Access Compliance Report

(Island Curb Cuts)

Intersection ID: 12517	Main Street: N_SHARON_AMITY_RD	Cross Street: SHAMROCK_DR	Location: NE
ADA ID: 4C9FDEB15B1D	Curb Cut Type: MedianRefuge2	Initial Pass/Fail: Fail	Overall Compliance: No
Severity Score: 8.75			
Codes/Mitigation Info/Possible Solution		Field Measurements/Component Compliance

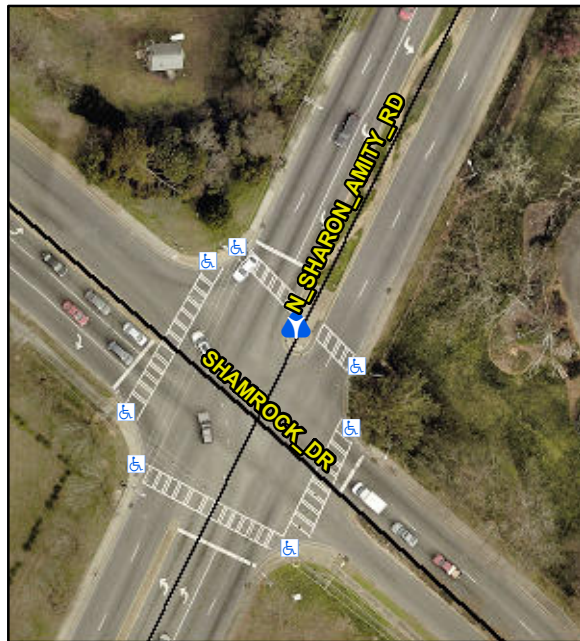
Compliance	Description	Data	Compliance	Description	Data
Yes	Refuge 1 Length (In)	84.0	N/A	Gutter 1 Ponding?	N/A
No	Refuge 1 Width (In)	48.0	N/A	Gutter 1 Lip Ht (In)	N/A
Yes	Refuge 1 Slope (%)	0.7	N/A	Gutter 1 Slope (%)	N/A
Yes	Refuge 1 X Slope (%)	0.4	N/A	Gutter 1 X Slope (%)	N/A
N/A	Painted X Walk1?	Yes	N/A	DWS 1 Provided?	N/A
N/A	X Walk 1 Direction	To SE	N/A	DWS 1 Contrast?	N/A
N/A	X Walk 1 Width (In)	95.0	N/A	DWS 1 Length (In)	N/A
N/A	Road 1 Slope (%)	0.5	N/A	DWS 1 Full Width?	N/A
N/A	Road 1 X Slope (%)	2.1	N/A	DWS 1 Offset (In)	N/A
Yes	Refuge 2 Length (In)	84.0	N/A	Gutter 2 Ponding?	N/A
No	Refuge 2 Width (In)	48.0	N/A	Gutter 2 Lip Ht (In)	N/A
Yes	Refuge 2 Slope (%)	0.5	N/A	Gutter 2 Slope (%)	N/A
Yes	Refuge 2 X Slope (%)	1.2	N/A	Gutter 2 X Slope (%)	N/A
N/A	Painted X Walk2?	Yes	N/A	DWS 2 Provided?	N/A
N/A	X Walk 2 Direction	To NW	N/A	DWS 2 Contrast?	N/A
N/A	X Walk 2 Width (In)	88.0	N/A	DWS 2 Length (In)	N/A

Remove & Replace Entire Refuge.
